# UNITED STATES PATENT AND TRADEMARK OFFICE

APPLICATION NO.	FILING DATE	FIRST NAMED INVENTOR	ATTORNEY DOCKET NO.	CONFIRMATION NO.
10/718,537	11/24/2003	William Gould	56920-00606	1267

**Office Action Summary**

## DETAILED ACTION

FIG. 1

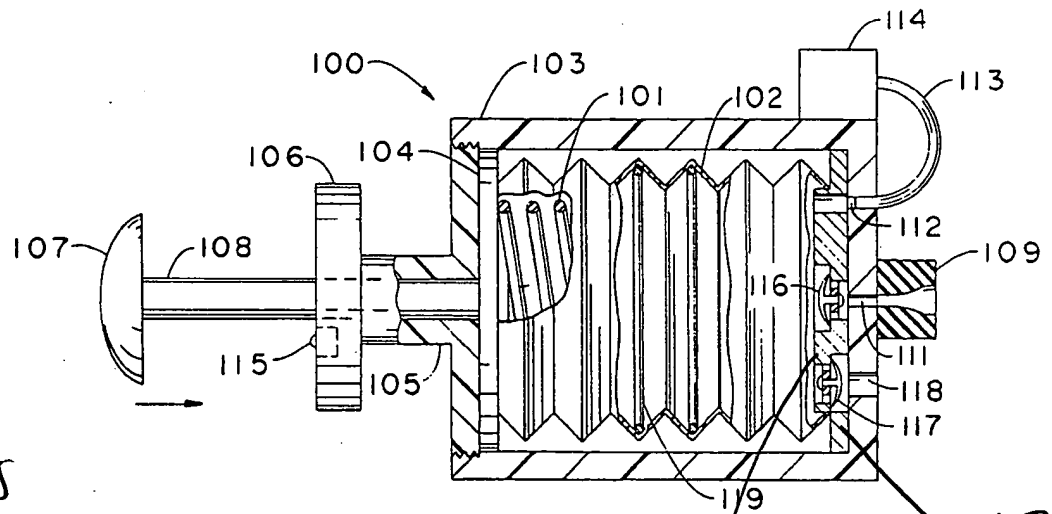
Kush et al. in Figure 1 teaches a vacuum system comprising a flexible container (102) having a generally rigid base wall (104) defining a first end of the container (102), a generally elongated and compressible cylindrical side wall (side wall of bellows 102) extending away from the base wall (104), and an opening (shown not enumerated, in which the valve plate is inserted into the end of the bellows 102) disposed at a second end of the container (102). A cap (see marked up Figure 1) is removably attached and sealed to the opening (shown not enumerated). The cap has a first coupler (see axial engaging surface on which the bellows opening is mounted) and includes a means (inner surface) for receiving a biasing force urging the cap away from the opening (shown not enumerated). A helically wound spring (101) is disposed within the container (102) and extends between the cap (see marked up Figure 1) and the base wall (104). Valves (116, 117) communicate with the first coupler and are mounted on the cover (see marked up Figure 1).

Examiner's  
Marked  
Up Figure  
Please Include  
in Office Action
